# **APPENDIX C**

## **Stakeholder Feedback Session on Design Scenarios – September 30, 2013**

**54<sup>th</sup> Street Reconstruction  
and Arden Park Stormwater  
Management Plan**

## M1+2 Boat landing type

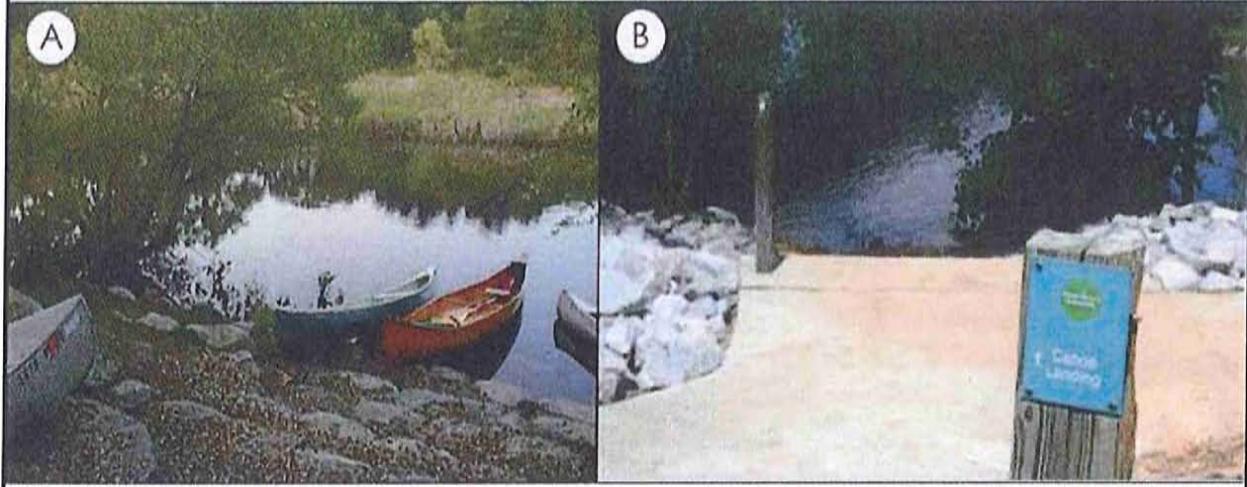
- A, more natural
- We like A.
- Not necessary
- Option A is the far better option. This area is currently fairly natural and wild. Maintaining a more natural landing is more fitting. However, there is really no need currently to change the landing south of 54th street. This is a deck style landing and completely adequate the way it is.

- A
- ... The "B" look which paves over everything.
- A
- Natural
- A is preferred
- The "A" look has a much more natural and better aesthetic than...
- I like the more natural look

## M1+2 Grass pavers to control erosion, and location

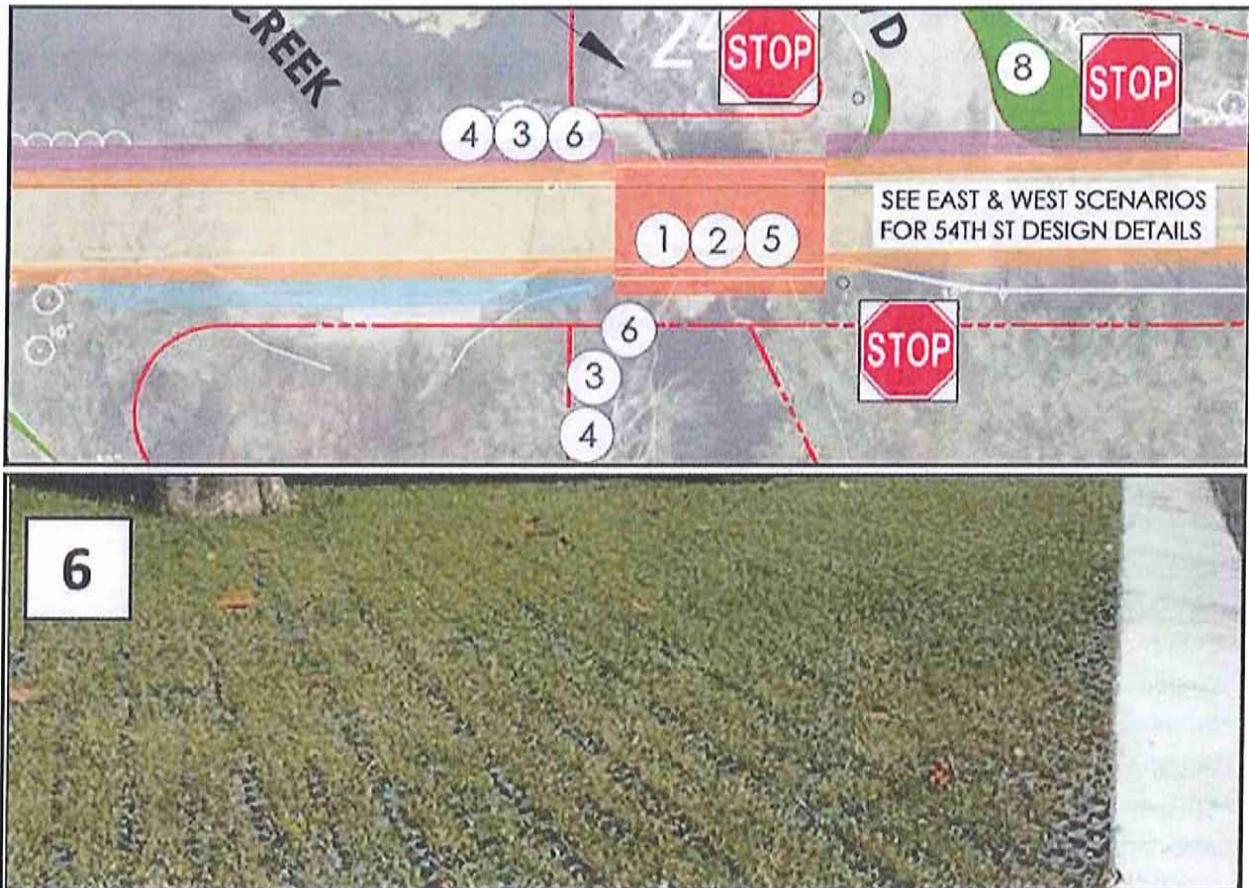
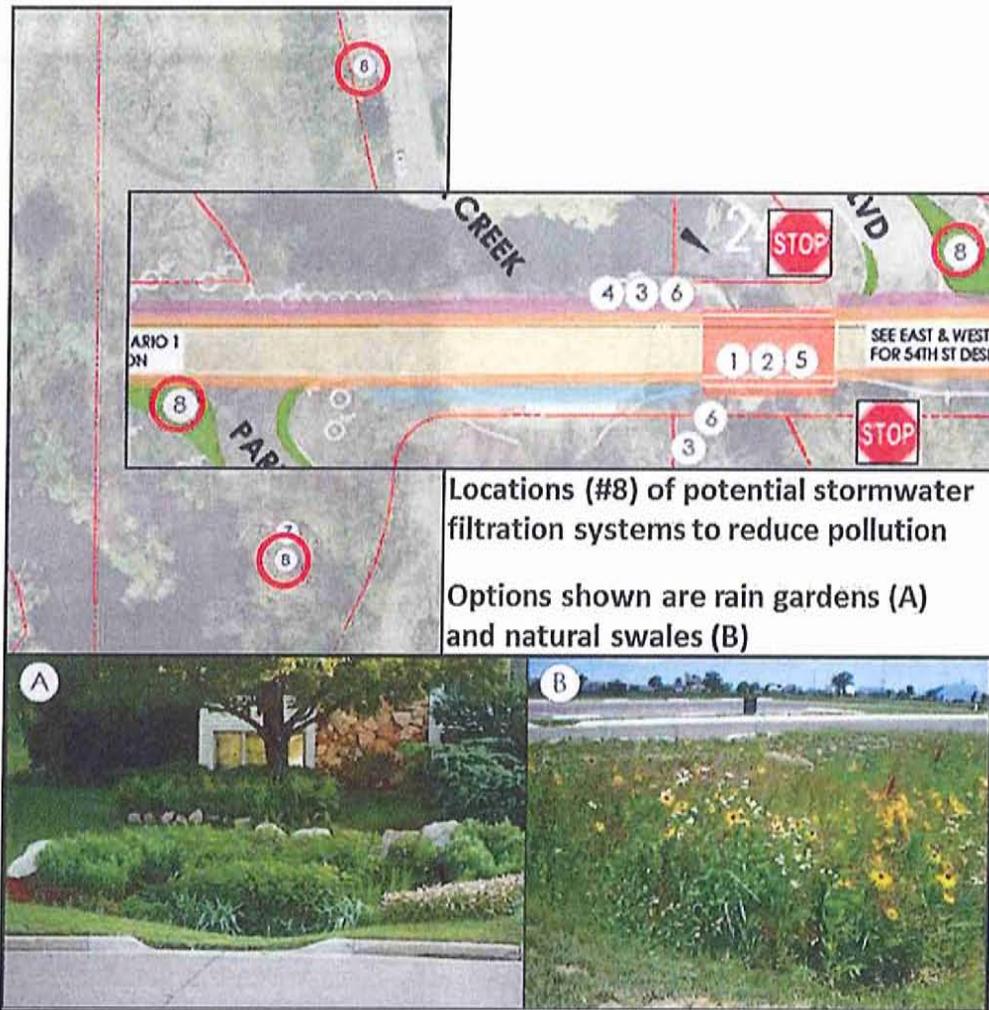
- Good
- good idea
- like the idea, but don't appreciate the use of the creek...too few users to put this much investment into a few months of enjoyment for the minority of people that use it for this purpose.
- Grass paver are a great idea for specific areas.
- Yes
- these look good
- yes
- no, looks ugly and unnatural
- 
- this is unclear
- Yes
- Seems to be a good idea
- No opinion either way here...

- Yes.
- Looks ok
- Good idea

## M1+2 Bridge design preferences

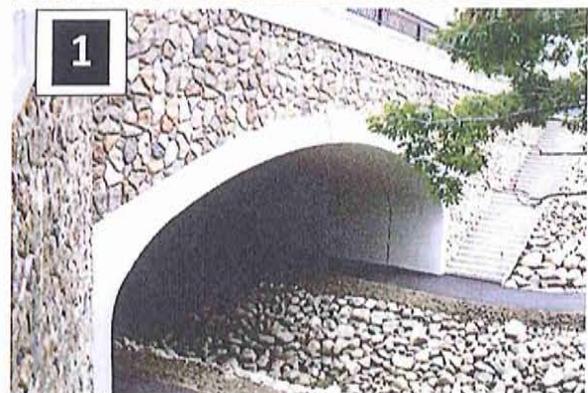
- Priority order - 10, 4, 1
- The best bridge design would be one that maximizes the space under the bridge for creek users to pass under.
- 4 is the only appealing bridge - the others provide a lot more spaces for graffiti and defacing;

## West, Scenario 1: Highlights and Unique Features

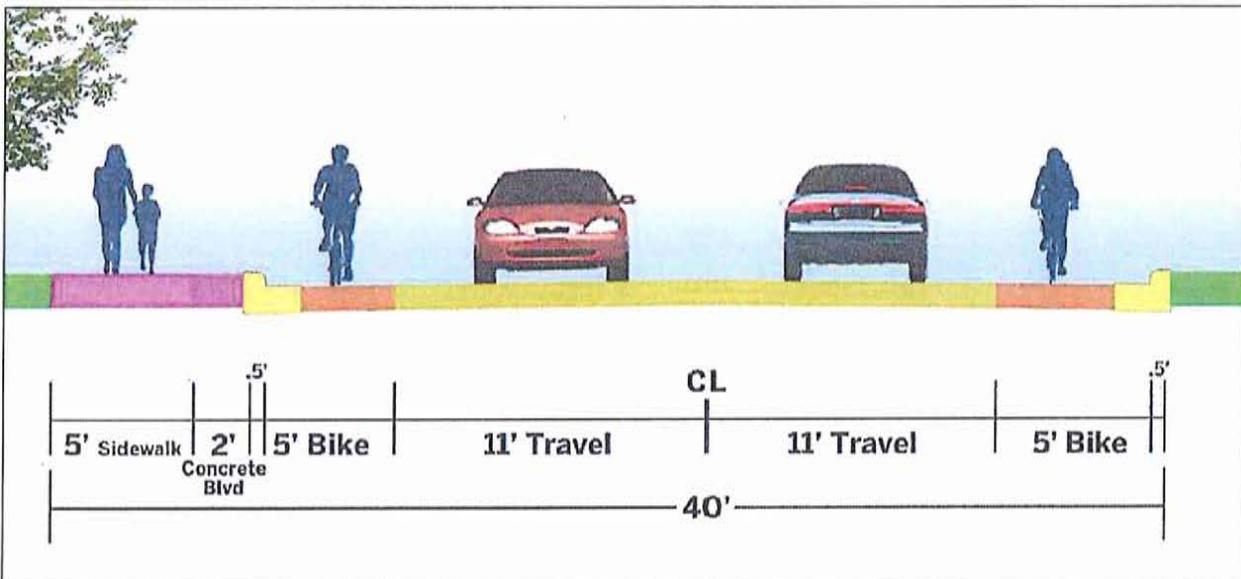
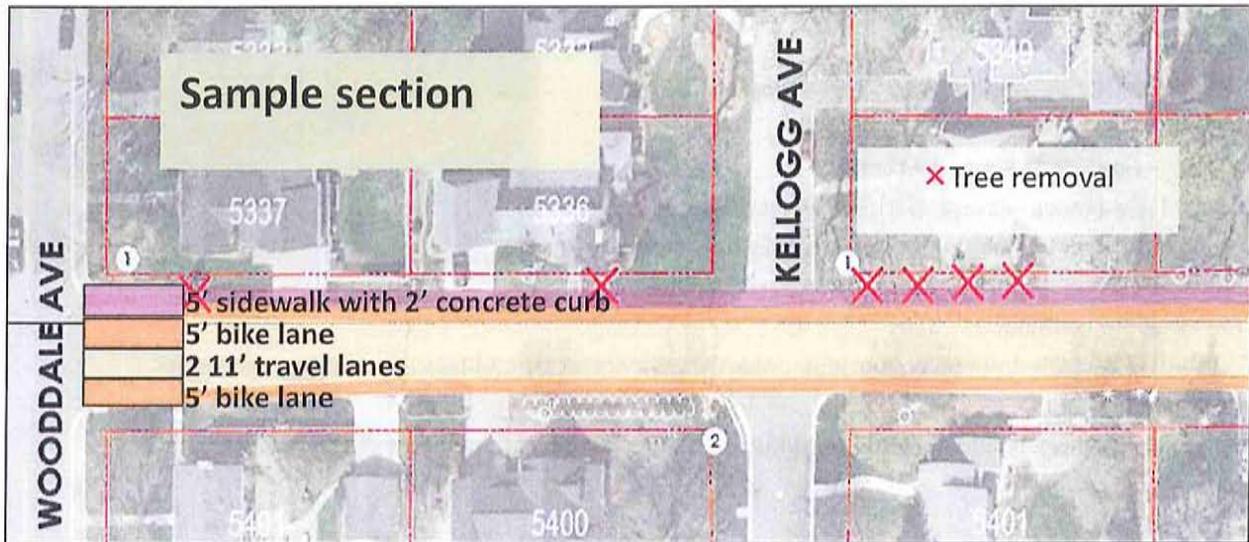
- I know I am in the minority but 40' is not too wide, given that 5' of that is for sidewalks that make our neighborhood safer. I also bike and appreciate the lanes
- Agree with no parking
- yes to sidewalks on north side of 54th
- Sidewalk
- None...To evasive
- very little
- nothing is appealing about this scenario
- Side walk
- This is a good plan, even with tree removal
- Absolutely Nothing!
- Nothing is appealing - there is a better way to achieve goals with a far less negative impact
- Nothing...Hate it. we do not need dedicated bike lanes
- Dedicated bike lanes.
- not appealing at all
- Sidewalk
- This scenario is a nightmare for the property owners on 54th
- There is NOTHING appealing about widening to 40 ft.!!!!
- Like bike lanes, sidewalk
- yes to center line for cars on 54th
- best safety approach
- Bike lanes

- Do not widen street! Willing to forgo parking
- Dislike due to removal of trees: agree!
- There is no good reason to remove trees: agree!
- 40' roadway is too wide. Too close to houses: agree!

- Inequitable amount of land taken from North side of street for sidewalk
- The street and add-ons are MUCH TOO WIDE
- 2 ft. concrete boulevard. is unnecessary

- what is the budget?
- North side bears the brunt of the expansion; NOT fair to those residents; REALLY?.Replace garage? NO! Unnecessary expense and absolutely UNACCEPTABLE! Just don't encroach much further onto property!

### West, Scenario 2: Highlights and **Unique** Features

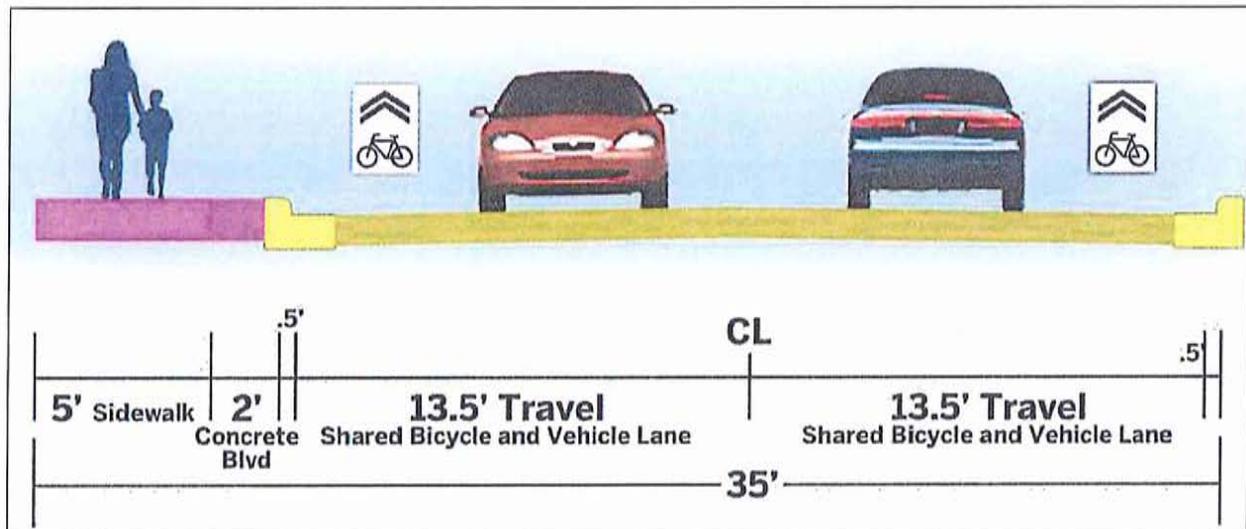
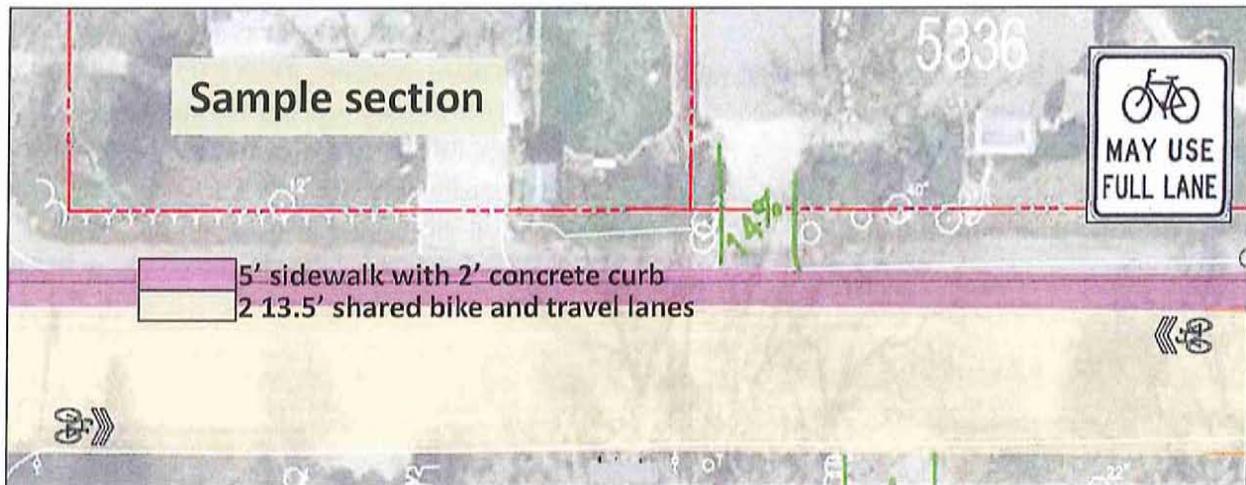
- Scenario 2 better than 1
- Prefer this plan. Less loss of trees
- sidewalk
- Shared bike lanes;
- Keeping the road as narrow as possible.
- Better, share Bike and Car lane, forces cars to SLOW down.

- This is a far superior alternative. It achieves key objectives with fewer negative impacts
- No dedicated bike lanes is good. sidewalk is good
- this is the preferred scenario with modifications

- This is a narrow WOL.
- All the expansion is to the north. It's better to bury the power lines and balance the width increase between the north and south side. Also, narrow the travel lane to 12 to 13 feet - This way key objectives can be met with no change to the total width of the street.

- Get rid of 2 foot curb,
- only need 1 foot curbs, no rumble strip , drawing is not centered
- Still 1' wider than necessary; 34' CENTERED along the 60' right-of-way can work along 54th from Wooddale to bridge

- Tree removal.
- loss of side yard space only on the north side of street
- improvement is not centered on the street right of way
- The plans show the "eroded" areas like that is a lot line. A 7' sidewalk is completely unnecessary! We

- Do these replace utility pole lights?
- Is the road centered
- Why not center-split the loss between North and South?
- Can sidewalk go to south side? Church, school bus stops, bridge, businesses, etc.

- Why remove the trees?
- Why do we need a 2' concrete curb? Why 13.5 ft. travel lanes vs. 11 ft.? Other streets with shared bike lanes have 11 ft.
- Have lanes, curbs, sidewalk designed into current width. Remove bike share.
